**GIECK RANCH TRIBUTARY
WEST FORK REACH 7A
CHANNEL ANALYSIS REPORT
FOR
SADDLEHORN RANCH FILING NO. 4**

**May 4, 2023
Project No. 25142.06**

**El Paso county PCD File No:
SF-XX-XXX ← SF236**

(following comments are from first submittal)

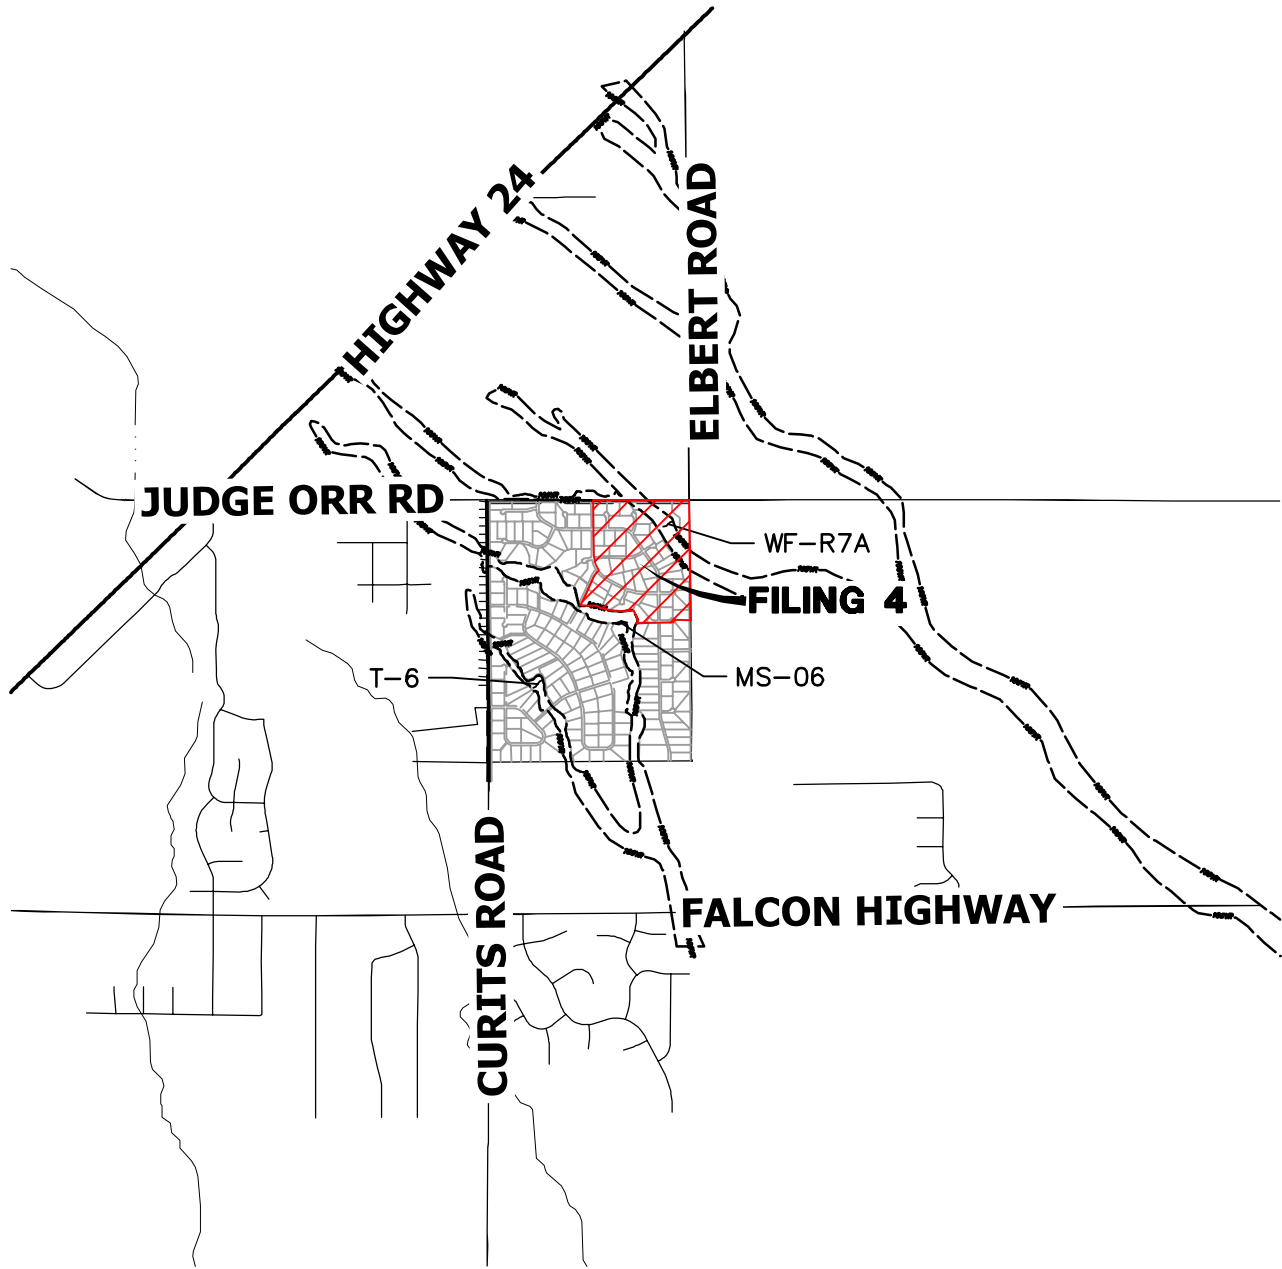
Were analyses done for both velocity and depth?
Depth would use 0.033

FLOODPLAIN MAP
 SADDLEHORN RANCH - FILING 4
 JOB NO. 25142.06
 3/3/22
 SHEET 1 OF 1

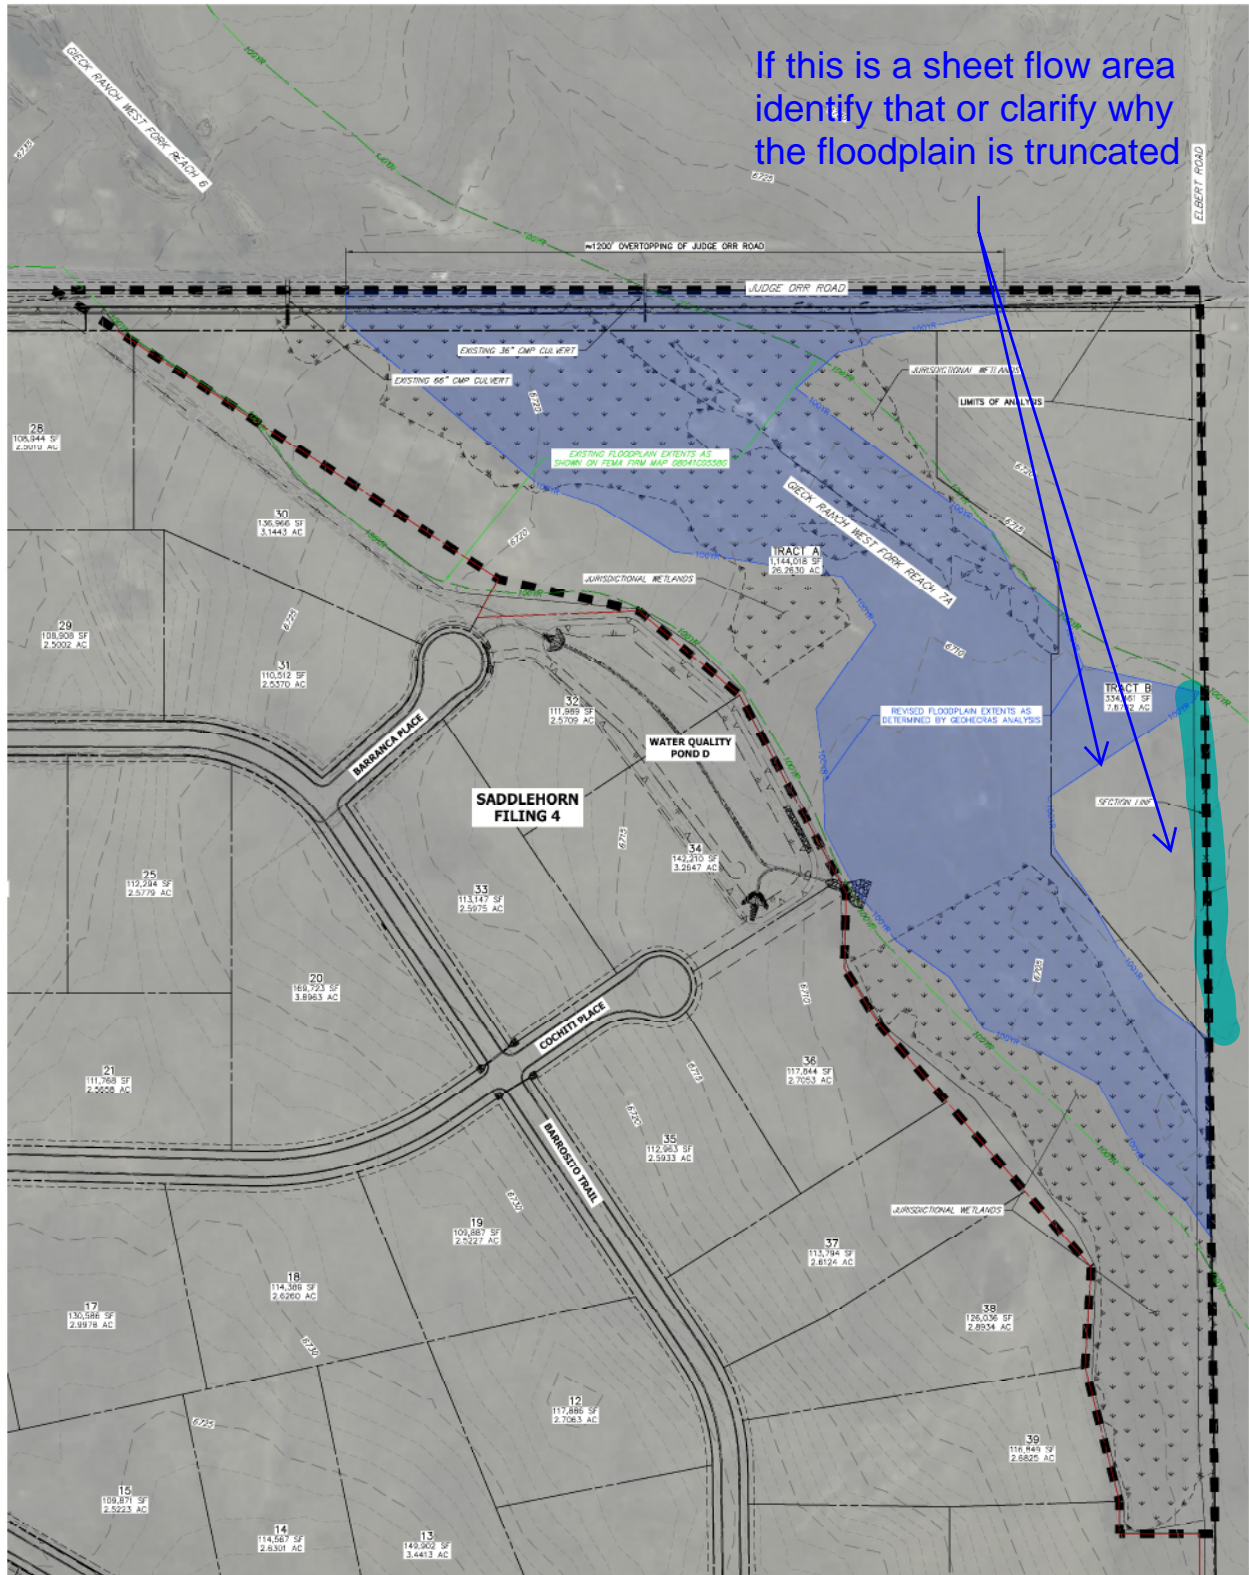
If this is a sheet flow area identify that or clarify why the floodplain is truncated

These are reversed

Also provide a working map and plan and profile
